Access Compliance Report

Public Rights-of-Way

Intersection ID: 49292	Main Street: ROYAL_WINCHESTER_DR	Cross Street: CHAMBERLIN_RD	Location: NW
ADA ID: BA06339C2BA9	Ramp Type: PerpDiag	Initial Pass/Fail: Pass	Overall Compliance: No
Codes/Mitigation Info/Possible Solution		Field Measurements/Component Compliance	
Severity Score: 7.5

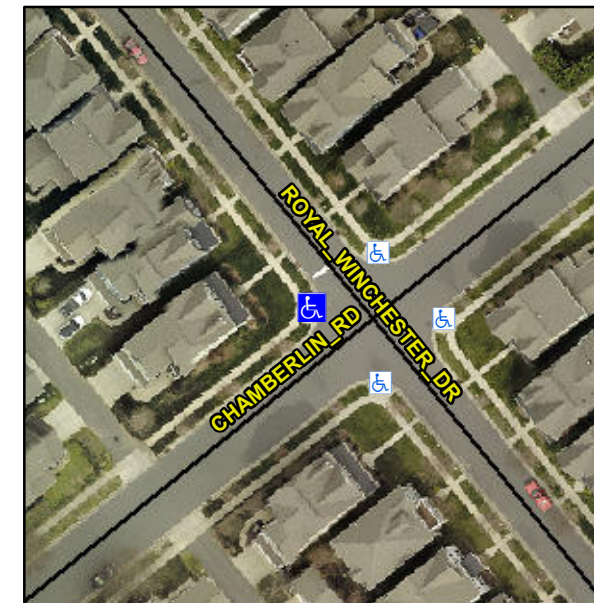
R304.2.1, R304.2.2-Perp, R304.3.2-Para, R304.5.3, R305.2, R302.7.2

Compliance	Description	Data	Compliance	Description	Data
N/A	Ramp Length (in)	72.0	Yes	Ramp Slope (%)	7.8
Yes	Ramp Width (in)	48.0	Yes	Ramp XSlope (%)	2.0
N/A	Flare Type LT	Sloped	N/A	Flare Type RT	N/A
N/A	Flare Slope LT (%)	1.9	Yes	Flare Slope RT (%)	9.6
N/A	Flare Traversable LT?	Yes	N/A	Flare Traversable RT?	Yes
No	Landing Length (in)	46.5	Yes	DWS Provided?	Yes
Yes	Landing Width (in)	48.0	Yes	DWS Contrast?	Yes
No	Landing Slope (%)	2.8	Yes	DWS Length (in)	24.0
No	Landing X Slope (%)	3.0	Yes	DWS Full Width?	Yes
N/A	Landing Curb? (Y/N)	No	No	DWS Offset (in)	5.0
N/A	Shared Landing?	No			
Yes	Gutter Ponding?	No	Yes	Gutter Slope (%)	1.8
No	Gutter Lip Ht (in)	0.5	Yes	Gutter X Slope (%)	0.7
N/A	Painted X Walk1?	No	N/A	Painted X Walk2?	No
	X Walk 1 Direction	To SE		X Walk 2 Direction	To NE
N/A	X Walk 1 Width (in)	N/A	N/A	X Walk 2 Width (in)	N/A
	X Walk 1 Slope (%)	2.3		X Walk 2 Slope (%)	0.5
	X Walk 1 X Slope (%)	2.4		X Walk 2 X Slope (%)	0.3

Remove & Replace Curb Ramp With Two New Directional Ramps or Equivalent. Grind Gutter Lip.
